Access Compliance Report

Public Rights-of-Way

(Curb Ramps)

Intersection ID: 10033082	Main Street: NORTH_REA_PARK_LN	Cross Street: N/A	Location: N
ADA ID: 6D12099BD1BD	Ramp Type: Perp	Initial Pass/Fail: Pass	Overall Compliance: No
			Severity Score: 0.25
Codes/Mitigation Info/Possible Solution		Field Measurements/Component Compliance

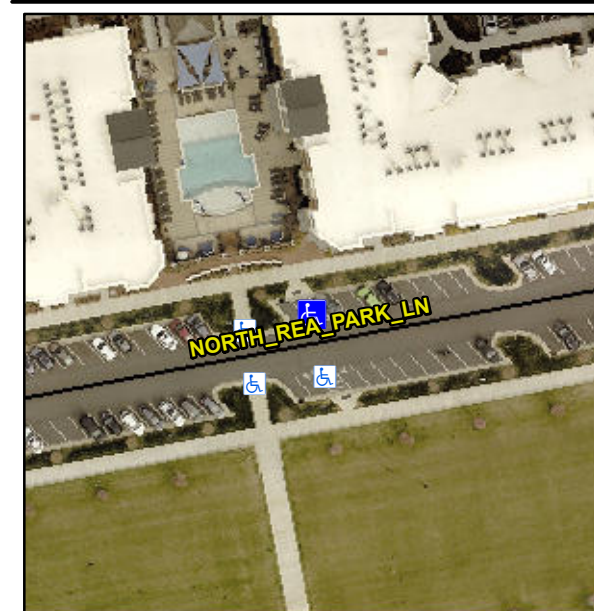
Not Found, R304.5.3, R304.2.2-Perp, R304.3.2-Para

Compliance	Description	Data	Compliance	Description	Data
N/A	Ramp Length (in)	94.5	Yes	Ramp Slope (%)	7.4
Yes	Ramp Width (in)	60.0	No	Ramp XSlope (%)	3.0
N/A	Flare Type LT	Sloped	N/A	Flare Type RT	N/A
N/A	Flare Slope LT (%)	6.8	Yes	Flare Slope RT (%)	6.6
N/A	Flare Traversable LT?	Yes	N/A	Flare Traversable RT?	Yes
Yes	Landing Length (in)	96.0	Yes	DWS Provided?	Yes
Yes	Landing Width (in)	62.0	Yes	DWS Contrast?	Yes
No	Landing Slope (%)	2.5	Yes	DWS Length (in)	24.0
Yes	Landing X Slope (%)	0.8	Yes	DWS Full Width?	Yes
N/A	Landing Curb? (Y/N)	No	Yes	DWS Offset (in)	0.0
N/A	Shared Landing?	No			
Yes	Gutter Ponding?	No	Yes	Gutter Slope (%)	3.2
Yes	Gutter Lip Ht (in)	0.0	Yes	Gutter X Slope (%)	0.5
N/A	Painted X Walk1?	No	N/A	Painted X Walk2?	N/A
	X Walk 1 Direction	To S		X Walk 2 Direction	N/A
N/A	X Walk 1 Width (in)	N/A	N/A	X Walk 2 Width (in)	N/A
	X Walk 1 Slope (%)	4.3		X Walk 2 Slope (%)	N/A
	X Walk 1 X Slope (%)	0.5		X Walk 2 X Slope (%)	N/A

Remove & Replace Entire Ramp.
